APPLICATION NO.	FILING DATE	FIRST NAMED INVENTOR	ATTORNEY DOCKET NO.	CONFIRMATION NO.
10/699,642	11/04/2003	Alex Hornig	HORN3170/EM	5376
23364	7590	03/11/2005	EXAMINER	
BACON & THOMAS, PLLC 625 SLATERS LANE FOURTH FLOOR ALEXANDRIA, VA 22314			EDGAR, RICHARD A	
			ART UNIT	PAPER NUMBER
			3745

Office Action Summary	Application No. 10/699,642	Applicant(s) HORNG ET AL.	
	Examiner Richard Edgar	Art Unit 3745

DETAILED ACTION

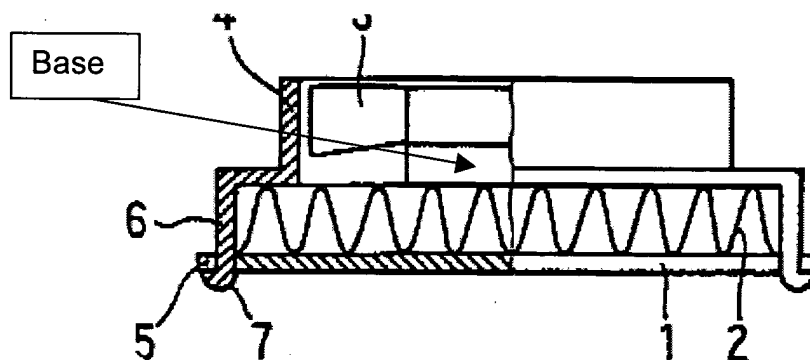
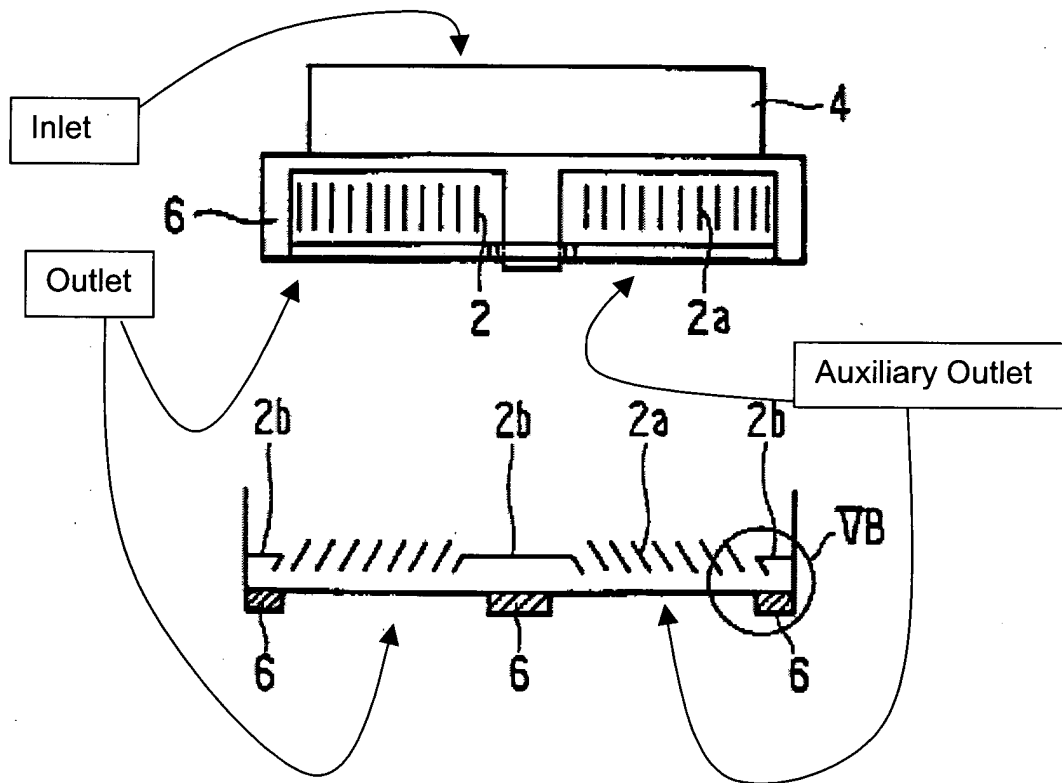
Yamaguchi et al. disclose in Figs. 3-5, an airflow guiding structure for a heat dissipation fan, comprising: a housing 4, 6 provided with an air inlet and an air outlet; a base mounted in the air outlet for supporting a fan wheel 3 which forms with a plurality of blades; at least one auxiliary air outlet formed on the housing proximate the air outlet;

and a plurality of air guiding members 2a arranged in the air outlet and inclined to the axis (radial axis, for instance) of the housing, the auxiliary air outlet being adjacent to the guiding members; wherein when the fan wheel rotates, the guiding members deflect airflow to constitute at least two airflow directions at the air outlet and the auxiliary air outlet. See annotated Figures below.

Regarding claim 2, the outlet and auxiliary outlet are connected, as seen in Figure 3, by part of the housing 6.

As for claim 6, the Yamaguchi et al. reference shows a supporting rib 2b with a vertical width and axial orientation.

Regarding claim 7, the guiding members 2a, which form member 2b, constitute an inverted "V" section (see Figure 5A). Furthermore, Figure 4 shows that the examiner identified supporting base (annotated Fig. 4) is supported by the guiding members 2.

The guiding members 2a are shown regularly inclined.
